Product / Process Change Notification (PCN)					
<input checked="" type="checkbox"/> Major change <input type="checkbox"/> Minor change					
<p>PCN #: PCN_UtWPCC-Tx_20240108</p> <p>Affected Series: WE-WPCC-Tx; 760308100111</p> <p>PCN Date: December 08, 2023</p> <p>Effective Date: January 08, 2024</p>	<p>Change Category:</p> <input type="checkbox"/> Equipment / Location <input checked="" type="checkbox"/> General Data <input checked="" type="checkbox"/> Material <input checked="" type="checkbox"/> Process <input checked="" type="checkbox"/> Product Design <input type="checkbox"/> Shipping / Packaging <input type="checkbox"/> Supplier <input type="checkbox"/> Software				
<p>Contact: Product Management</p> <p>Phone: +49 (0) 7942 - 945 5001</p> <p>Fax: +49 (0) 7942 - 945 5179</p> <p>E-Mail: pcn.eisos@we-online.com</p>	<p>Data Sheet Change: <input checked="" type="checkbox"/> Yes <input type="checkbox"/> No</p> <p>Attachment: <input type="checkbox"/> Yes <input checked="" type="checkbox"/> No</p>				
<p>Description and purpose of change:</p> <p>As a datasheet information amendment, Würth Elektronik will update the DC resistance specification. In addition to improve processability, a PE

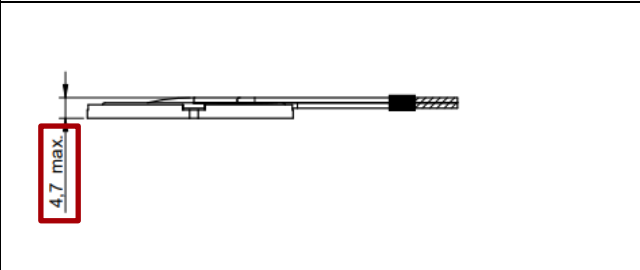
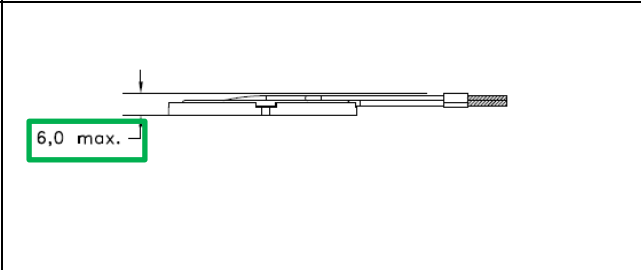
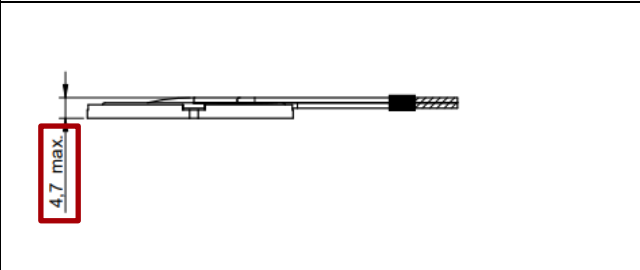
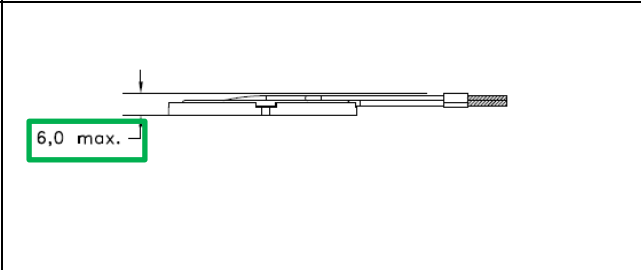
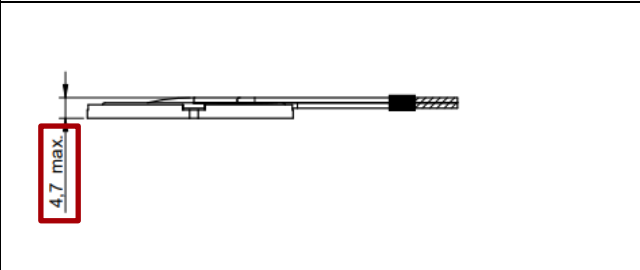
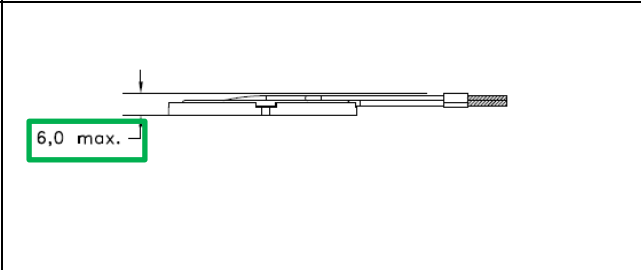
<p>The DC resistance specification will be updated</p> <table border="1" style="width: 100%; border-collapse: collapse;"> <thead> <tr> <th style="width: 50%; padding: 5px;">From</th> <th style="width: 50%; padding: 5px;">To</th> </tr> </thead> <tbody> <tr> <td style="text-align: center; padding: 10px;"> <div style="border: 1px solid red; padding: 2px; display: inline-block;">48 mΩ max</div> </td> <td style="text-align: center; padding: 10px;"> <div style="border: 1px solid green; padding: 2px; display: inline-block;">51 mΩ max</div> </td> </tr> </tbody> </table>		From	To	<div style="border: 1px solid red; padding: 2px; display: inline-block;">48 mΩ max</div>	<div style="border: 1px solid green; padding: 2px; display: inline-block;">51 mΩ max</div>
From	To				
<div style="border: 1px solid red; padding: 2px; display: inline-block;">48 mΩ max</div>	<div style="border: 1px solid green; padding: 2px; display: inline-block;">51 mΩ max</div>
